## Safety Notice

210002

**Subject:** Lower Turntable Rotation Bearing Retaining Fasteners

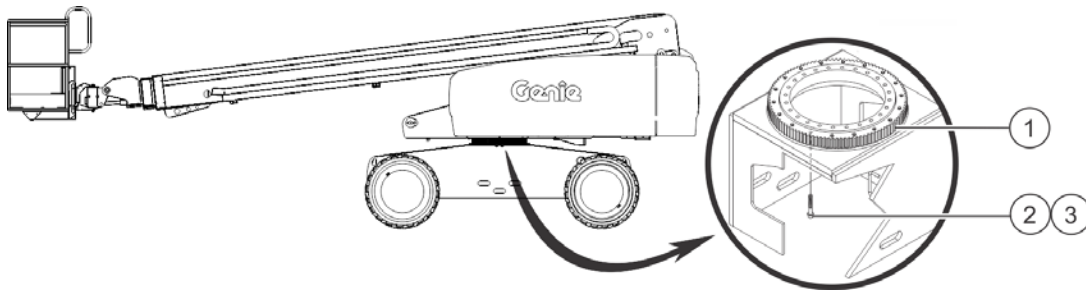
Genie has been notified of three instances where the lower turntable rotation bearing bolts in the machines referenced above have come loose causing the separation of the turntable from the chassis. **Separation of the turntable from the chassis can result in a machine tip-over or other structural failure.**

- 1 Turntable rotation bearing
- 2 Bolts, PN 1256170GT (18X)
- 3 Washer, PN 1256182 (18X)

**This Safety Notice requires replacing the lower turntable bearing fasteners on all machines listed in tables 1 and 2.**

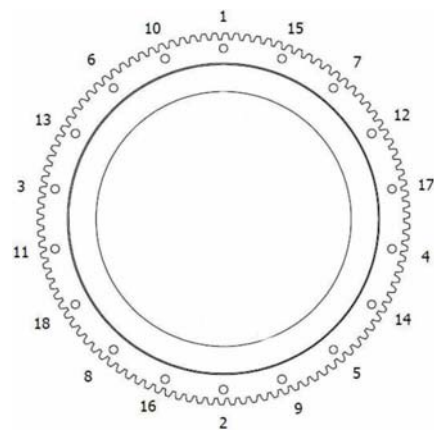
Working under the machine and in a star pattern, confirm that each lower turntable retaining fastener (18 X) is in place and torqued in sequence to the specification.

**Torque Specification = 180 ft-lbs / 244 Nm**
